SARA reference: 1911-13966 SRA
Council reference: D/99-2019

SARA response—98 - 1002 Yaamba Road, Parkhurst; 1014 - 1016 Yaamba Road, Parkhurst

(Referral agency response given under section 56 of the *Planning Act 2016*)

Description:	Development permit	Material Change of Use for Short-term Accommodation and a Relocatable Home Park.
SARA role:	Referral Agency.	
SARA trigger:	Schedule 10, Part 9, div 4, sub 1, table 1 (Planning Regulation 2017)— Development application for a material change of use for an aspect of development stated in Schedule 20: Development impacting on State transport infrastructure and thresholds

Figure 4.2 Access Arrangement Proposed in RNAU Documentation (from August 2018)

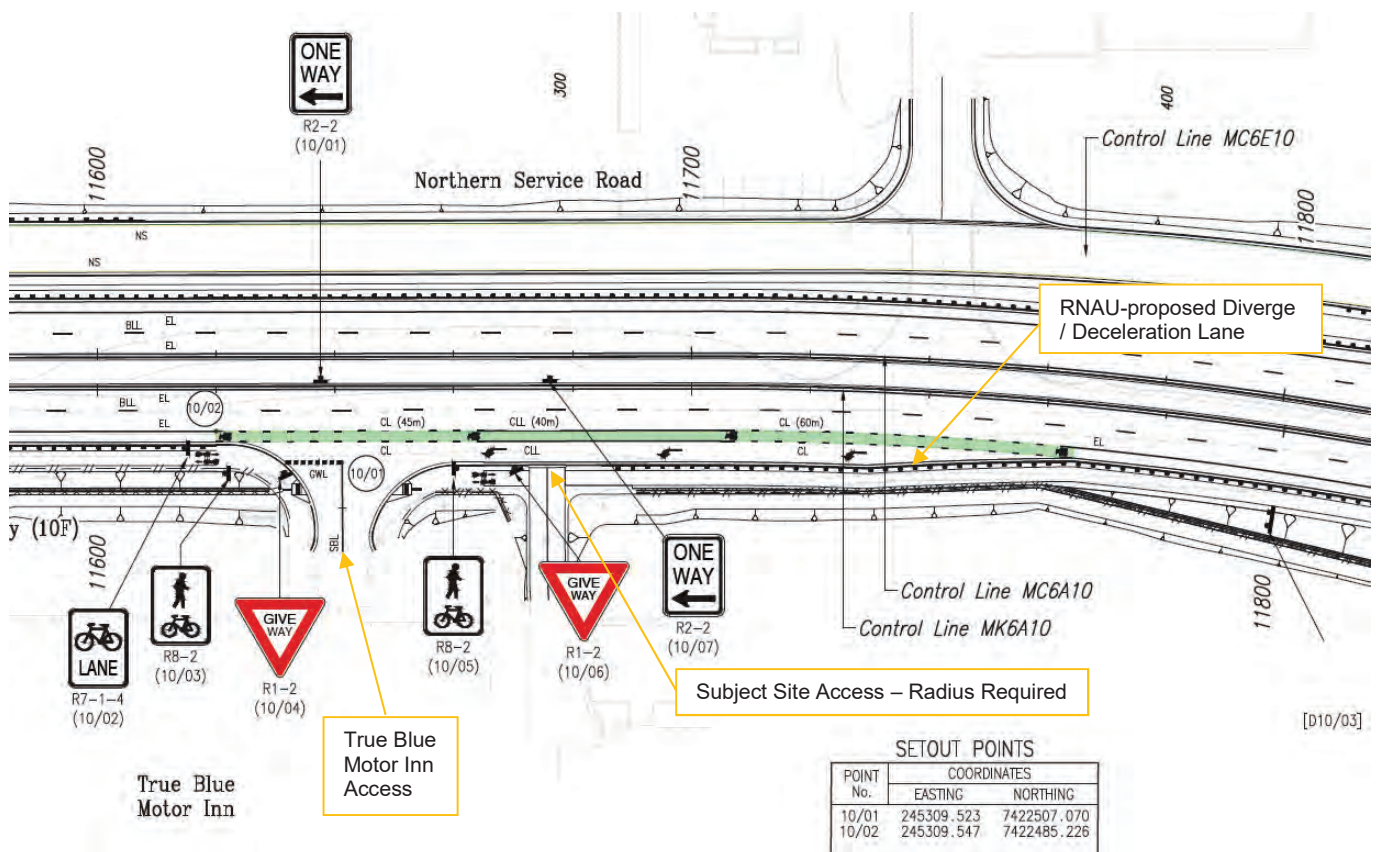
<p>generally in accordance with the Concept Road Functional Layout Plan shown in Figure 4.2 and Figure 4.3 of the <i>Engineering Infrastructure Report Proposed Development, 1014-1016 Yaamba Rd, Parkhurst</i> prepared by Calibre Professional Services Pty Ltd, dated 10 October 2019 and reference 18-002864.</p> <p>(b) Road access works comprising a fully lit Auxiliary Left Turn (AUL) treatment (at the road access location) must be provided generally in accordance with the Concept Road Functional Layout Plan, Figure 4.2 of the Calibre Professional Services Pty Ltd. Engineering Infrastructure Report 18-002864 dated 10 October 2019 by Calibre Professional Services Pty Ltd, including widening of the access throat (in accordance with Figure 4.3) to accommodate the simultaneous left in/left out movements of the maximum sized design vehicle (8.8m Medium Rigid Vehicle (MRV)).</p> <p>(c) The road access works must be designed and constructed in accordance with the relevant Department of Transport and Main Roads' Road Planning and Design Manual (2nd Edition) and Austroads Standards.</p>	<p>(b) and (c): Prior to the commencement of use.</p>

No.	Conditions of Approval	Condition Timing
1	The road access location is to be located at approximate Chainage 11,7km (RHS) (lat -23.286790; long 150.510012) and generally in accordance with the Concept Road Functional Layout Plan shown in Figure 4.2 and Figure 4.3 of the Engineering Infrastructure Report 18-002864 dated 10 October 2019 by Calibre Professional Services Pty Ltd, prepared for G & M Demedio for the Proposed Development, 1014-1016 Yaamba Rd, Parkhurst.	At all times.
2	Road access works comprising a fully lit AUL, (at the road access location) must be provided generally in accordance with the Concept Road Functional Layout Plan, Figure 4.2 of the Calibre Professional Services Pty Ltd Engineering Infrastructure Report 18-002864 dated 10 October 2019 by Calibre Professional Services Pty Ltd, including widening of the access throat (in accordance with Figure 4.3) to accommodate the simultaneous left in/left out movements of the maximum sized design vehicle (8.8m Medium Rigid Vehicle (MRV)).	Prior to commencement of use.

Figure 5: Noise barrier to achieve external noise criteria for residential building facades and private outdoor areas

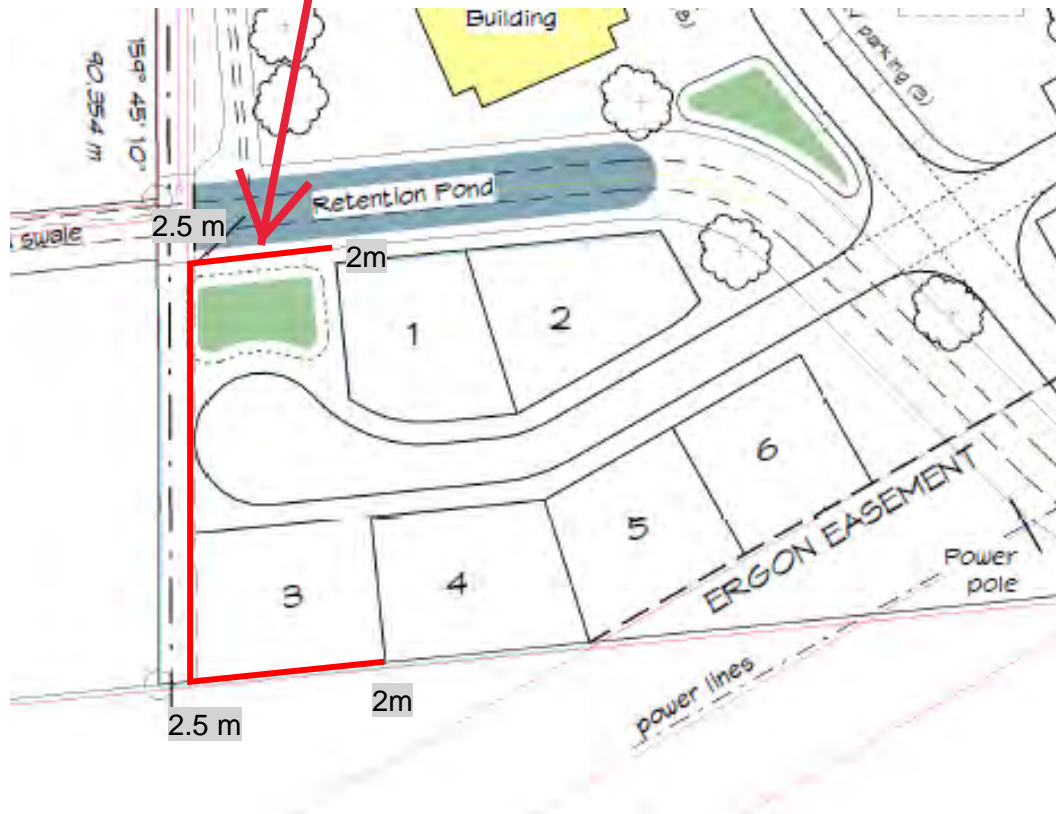
1.	<p>(a) Carry out the development generally in accordance with the report <i>Road Traffic Noise Assessment Motel Expansion and RV Home Sites</i> prepared by RoadPro Acoustics, dated 3 October 2019, reference 1277R1-R0 and Revision 0. In particular –</p> <ul style="list-style-type: none"> i. Construct a noise barrier in the location shown on Figure 5 prepared by RoadPro Acoustics, dated 3 October 2019, reference 1277R1-R0 and Revision 0, as amended in red to note that noise barrier heights are relative to either local preconstruction ground level, localised pad level, or final design surface, whichever is higher. <p>(b) The noise barrier must be designed in accordance with:</p> <ul style="list-style-type: none"> i. the Department of Transport and Main Roads' Road Traffic Noise Management Code of Practice, Chapter 5' Specifications MRS15 and MRTS15; and ii. Standard Drawings Road Manual, Part 13. <p>(c) RPEQ certification must be provided to the District Director (Fitzroy Region) within the Department of Transport and Main Roads, confirming that the development has been constructed in accordance with parts (a) and (b) of this condition.</p>	Prior to the commencement of use and to be maintained at all times
